10 November 2020

2190907

**RE: DA1166/2020 – RESPONSE TO REQUEST FOR ADDITIONAL INFORMATION  
COSTCO, BOOLAROO – 2A MAIN ROAD, BOOLAROO**

**Figure 1** Staging Plan

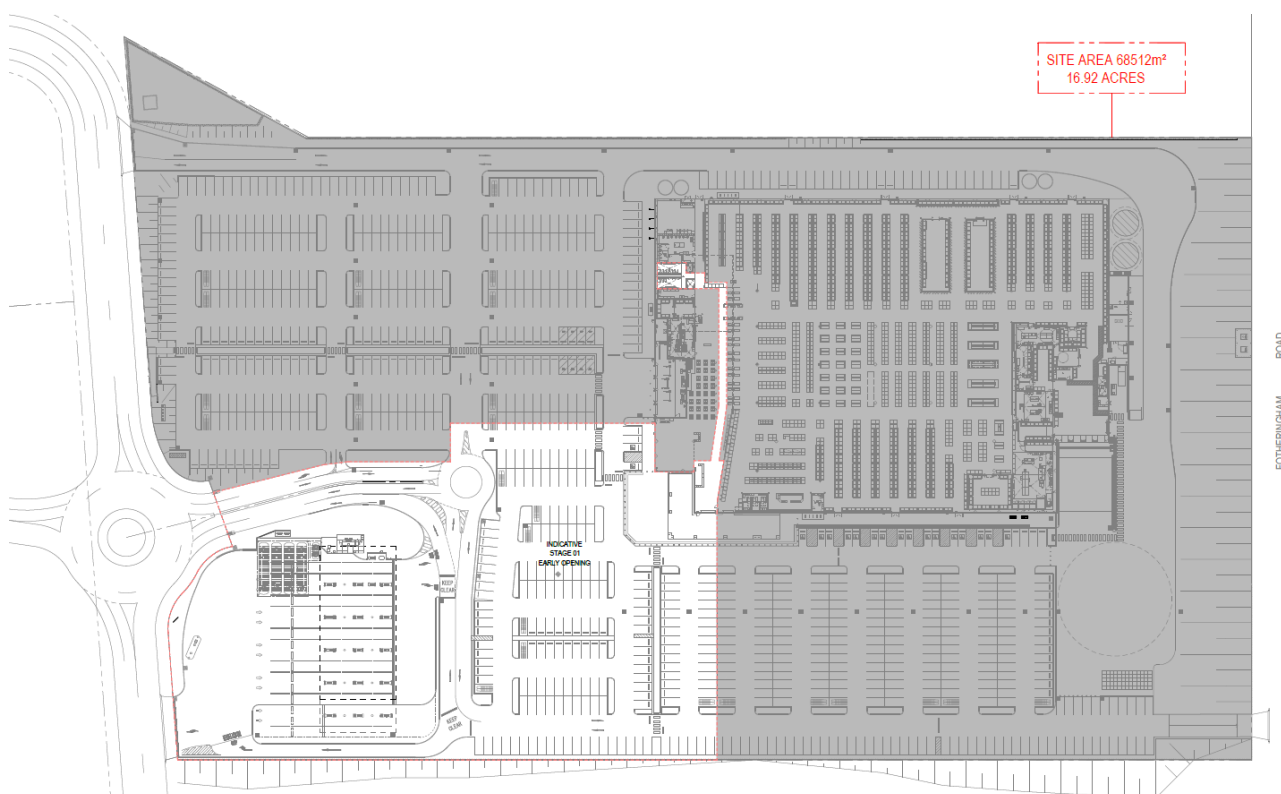
*The applicant to confirm if staging is included in the proposal. Plans appear to show staging however no further information could be found in this regard.*

It is intended that the entire development will be constructed in one stage except for the future service station extension.

Staged construction certificates and occupation certificates will be sought in line with the staging plan included in the Architectural Plans, prepared by Group GSA for the original application package.

It is proposed that the service station, the ancillary office component, membership desk, amenities and a small section of the car park located west of the service station will form part of the Stage 1 Early Opening (refer to **Figure 1**). Stage 1 will operate for approximately 4-6 weeks before Stage 2 is opened for customer use. Stage 2 will include the Costco Wholesale Warehouse and associated retail and business uses, the tyre centre and the remainder of the car parking.

Accordingly, Costco is likely to request a Construction Certificate (CC) for the whole development and then two separate Occupation Certificates (OC) for Stage 1 and Stage 2, respectively.

**Figure 2** Extract of Architectural Plan illustrating the proposed temporary jersey barriers.

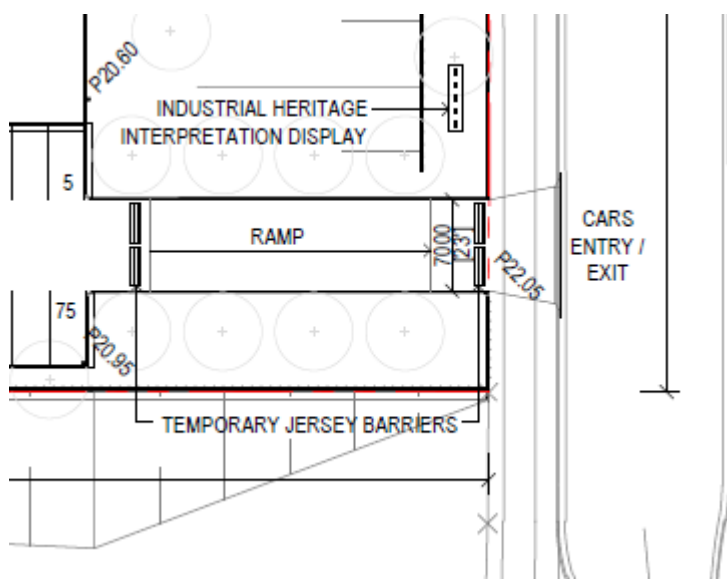
*There has been concern raised regarding the use of Fotheringham Street and Main Road as key access routes and the impact this would have on the local traffic network. Is there potential to remove this access and would this have any impact to emergency access for the development?*

Costco would like to continue to seek approval to construct a secondary access onto Fotheringham Road as proposed in the Architectural Plans in **Attachment A** as this ultimately reduces the pressure on the Hague Road and Reserve Road accesses in the long term. However, Costco are aware that use of that access will not be allowed until upgrade works to Fotheringham Road are completed. Accordingly, the Architectural Plans (**Attachment A**) and **Figure 2** illustrates that temporary jersey barriers will be installed at the top and bottom of the ramp to prevent use of the access in the short to medium term. Costco is happy to accept a condition of consent that restricts the use of the Fotheringham Road access until the upgrade works to Fotheringham Road are completed.

**Figure 3**      **Extent of Lot 599 in DP1228699**

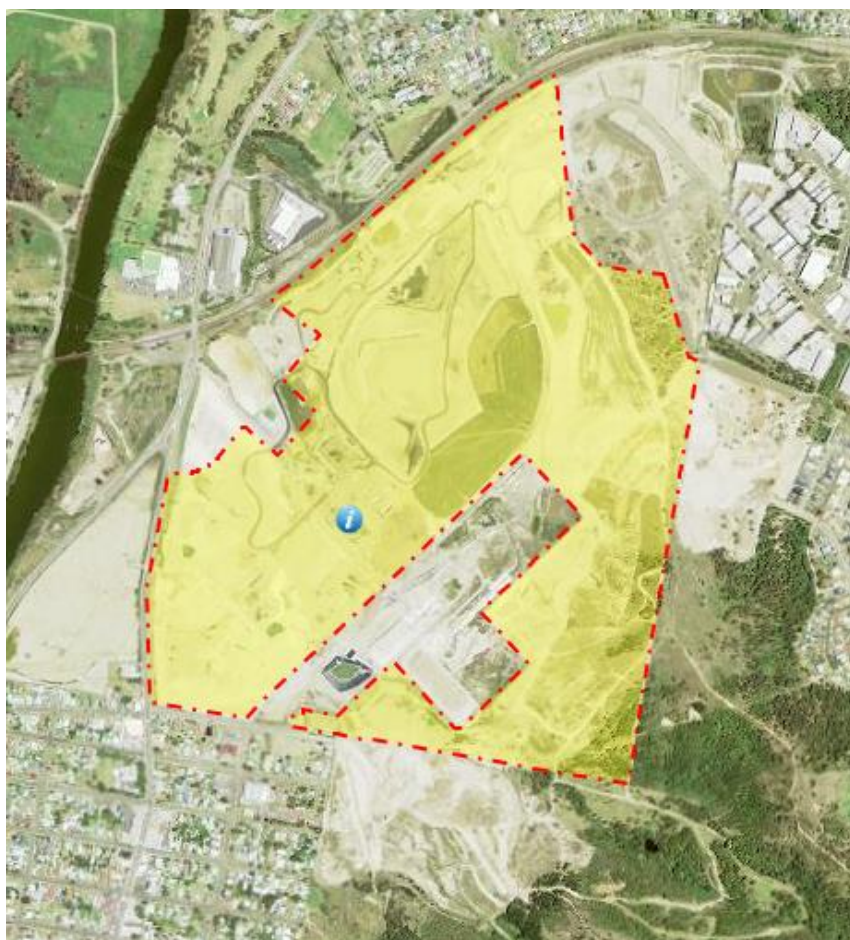
*Architectural plans show fill supported by batters that extend outside the proposed property boundary to the south west. All supports for cut and fill should be entirely located within the future property boundaries unless it can be shown that alternate arrangements have been made with the property owner.*

The existing topography of the site slopes upwards from west to east with a crossfall of approximately 7m. The proposed batters that extend outside the proposed property boundary to the east and west will be constructed by Costco, as indicated in the updated Architectural Plans at **Attachment A** and updated Civil Plans included at **Attachment C**. Hunter & Central Coast Development Corporation (HCCDC) are the owners of the land (Lot 599 in DP1228699) within the Costco site boundary and the surrounding land (refer to **Figure 3**) and have therefore already provided landowners consent.

**Figure 4** Location of the proposed acoustic fencing, nearest residential development shown in blue

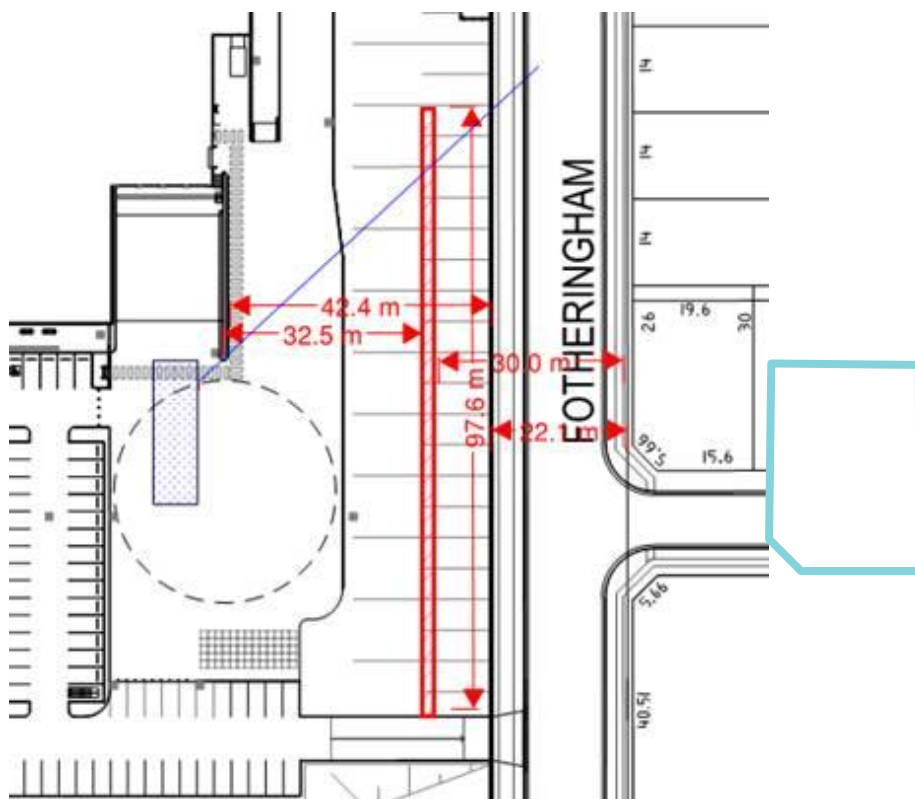
*Location of acoustic fencing to Fotheringham Road frontage requires clarification. If the fence is relocated toward the building the applicant is to ensure that acoustic commitments provided can still be maintained.*

*Clarification of hours of operation for the loading dock shall be provided.*

The proposed development will receive deliveries via the loading dock 24 hours per day. Various noise control measures for the loading dock were addressed in the Noise Impact Assessment, which recommended a number of mitigation measures to be put in place during operation. With particular reference to the loading dock, Norman Disney & Young recommended that acoustic fencing should be developed to mitigate the noise impact to surrounding residential area.

Specifically, the acoustic fencing will be located on the slope between the loading dock and the future residential area to the south east of the site, positioned 32m from the loading dock and 30m from the nearest residential development (south east of Fotheringham Road) (refer to **Figure 4**). The acoustic fencing will be constructed from either blockwood, concrete, fibre cement or plywood and will be 2.5m in height.

Once the acoustic fencing is constructed, the loading dock will emit a noise level of 35 dBA when measured from the nearest residential development (assuming a worst case scenario that a two storey house is developed on the site). The predicted noise level is compliant with the relevant night time noise criteria.
